RE: **The Point – Phases 1, 2, 6, & 9
FSP 23-04
Response to 2nd Final Subdivision Plat Review Comments
AWH-20000**

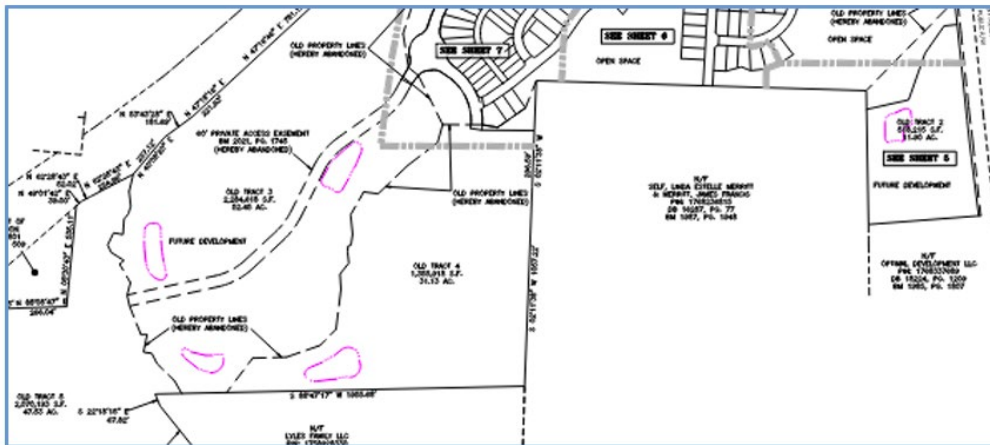
1. V1 Comment: The necessary offsite sanitary sewer extensions by the Point and Kalas Falls must be installed, inspected and accepted by Raleigh prior to the recording of this plat.
V2: This previous comment still stands. Below is Raleigh’s conditional approval note on the CDs. These conditions must be met prior to the point CD packed #1 recording lots.

CORPUD APPROVAL CONDITION:
 CONVEYANCE OF SEWAGE FROM THE PROPOSED LOTS WITHIN THE POINT SOUTH CD PACKAGE #1 WILL RELY ON IMPROVEMENTS TO THE HARRIS CREEK INTERCEPTOR THAT ARE BEING DESIGNED BY AMERICAN ENGINEERING. THE PLAN SET IS TITLED HARRIS CREEK SANITARY SEWER REPLACEMENT AND WILL BE ASSIGNED PERMIT # S-5037. THE POINT SOUTH CD PACKAGE #1 LOTS WILL NOT BE RECORDED AND THE ONSITE WATER/SEWER UTILITIES WILL NOT BE ACCEPTED BY RALEIGH UNTIL THE HARRIS CREEK INTERCEPTOR IMPROVEMENTS UNDER PERMIT # S-5037 ARE APPROVED, INSTALLED, AND ACCEPTED BY RALEIGH FOR MAINTENANCE.

McAdams Response: Noted.
